Solicitation Addendum

Addendum No.: 3

Solicitation Title: Veterans Park Seawall Repair and Dock Replacement

Addendum Date: March 22, 2017

1 EXISTING SURVEY - OVERALL
 S2.1
 GRAPHIC SCALE IN FEET

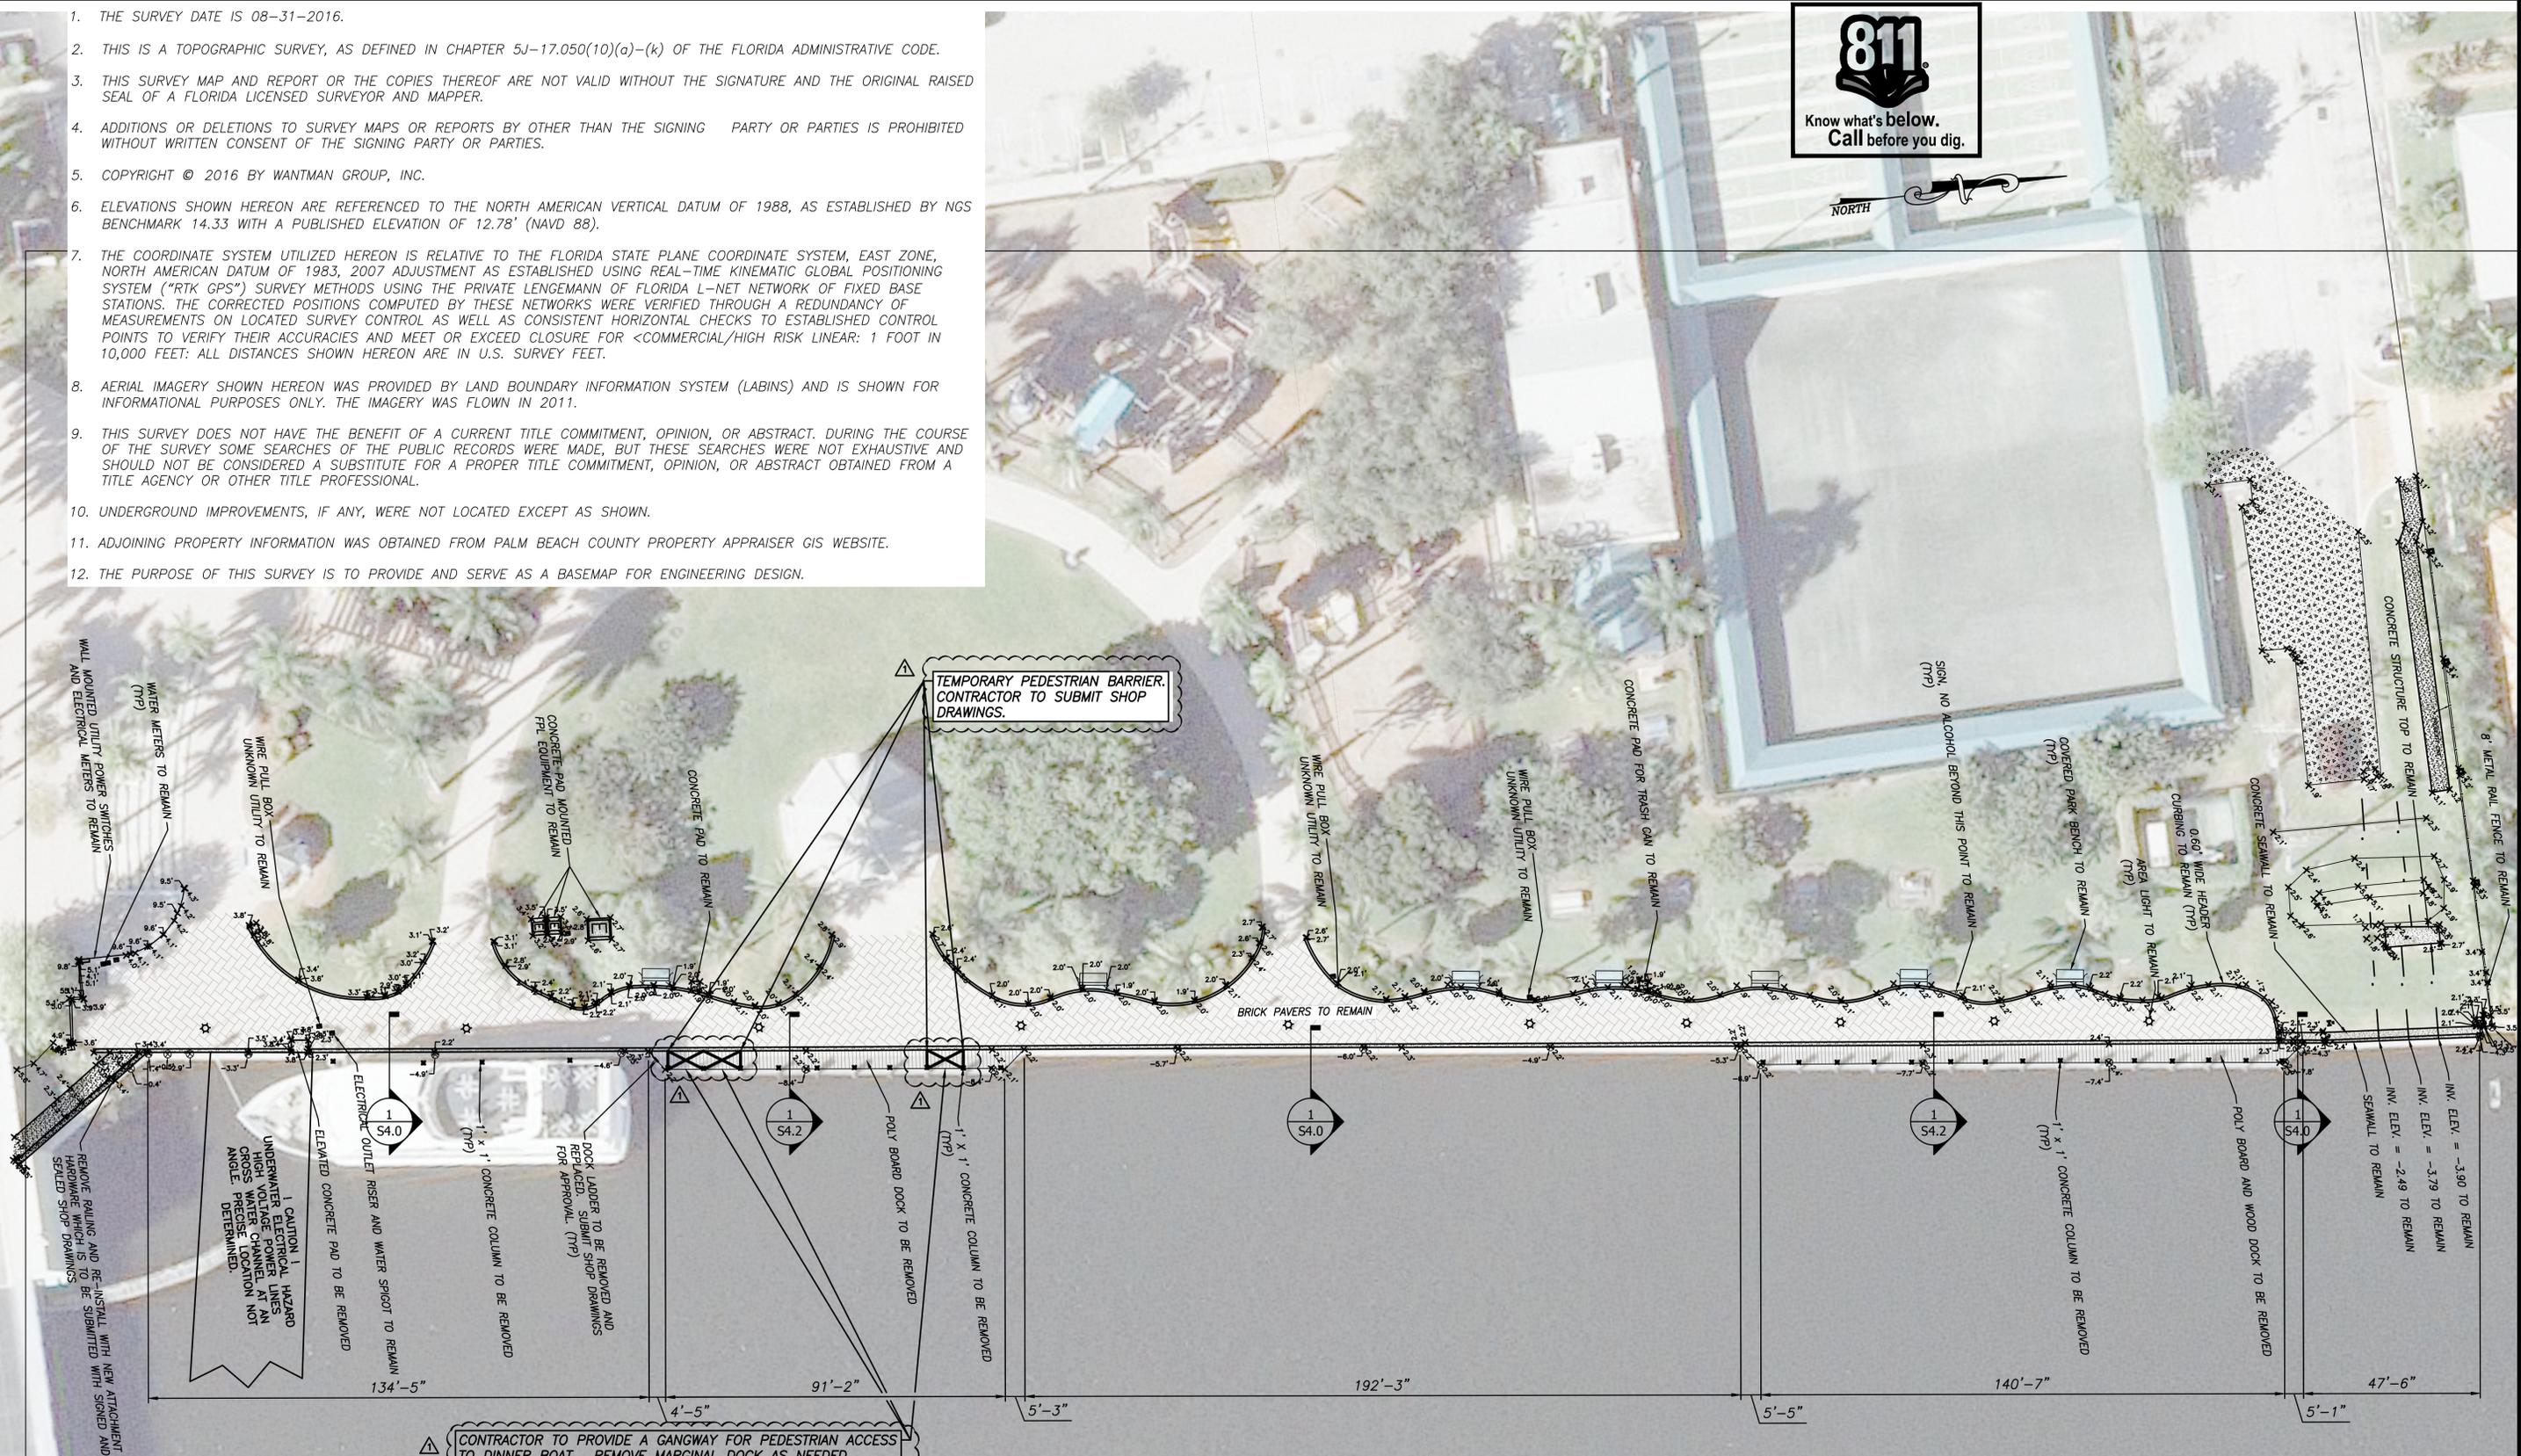
DESIGNED BY	TAD				
DRAWN BY	DAM				
CHECKED BY	TAD				
DATE	SEPTEMBER 2016	REVISION	DATE	DESCRIPTION	BY
		1	3/20/17	TEMPORARY REPAIRS	DAM

CONTRACTOR TO PROVIDE A GANGWAY FOR PEDESTRIAN ACCESS TO DINNER BOAT. REMOVE MARGINAL DOCK AS NEEDED.
 CONTRACTOR TO PROVIDE TEMPORARY MOORING CLEATS FOR THE DINNER BOAT.

2 **PROPOSED TYPICAL SEAWALL CAP**
S4.0
GRAPHIC SCALE IN FEET
ADD ALTERNATE
REPLACE REINFORCING WITH FRP, UON

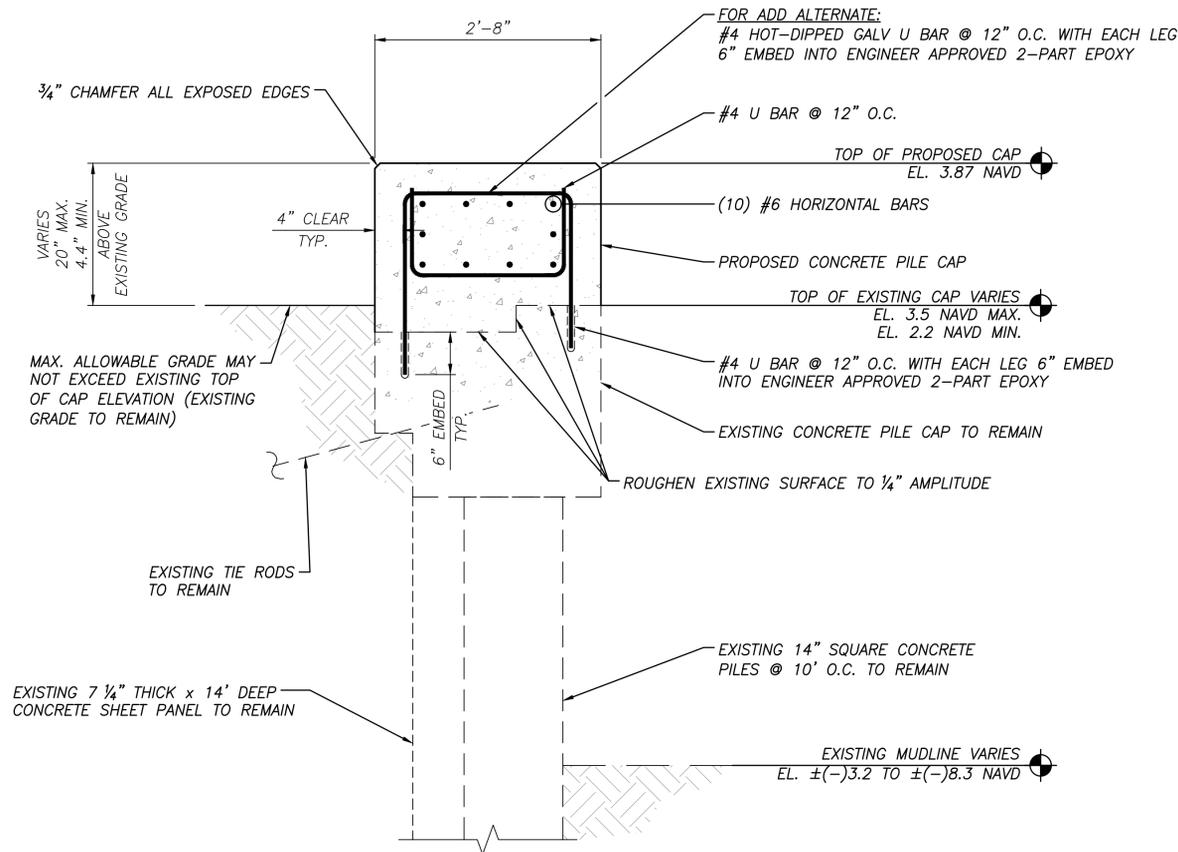
- Q2. Detail 2 on Sheet S4.0 specifies the finish elevation of the new cap as 3.897 NAVD. This detail also represents the maximum 20” raised cap. Detail 1 on Sheet S4.1 details an alternate cap to be used when the existing cap is within 8” of proposed cap. For the purposes of competitively bidding this project, and securing the best possible price for the City, is there a survey available that lists the current elevations of the existing cap so that we the bidders can determine how much of detail 2 on Sheet S4.0 (the large cap extension) or how much of detail 1 on Sheet S4.1 (the small cap extension) we are to bid on? Please advise.**

- R2. Sheet S2.0 is a survey of the existing wall with spot elevations along the length of the wall. Sheet S2.0 includes all survey information on the existing wall.
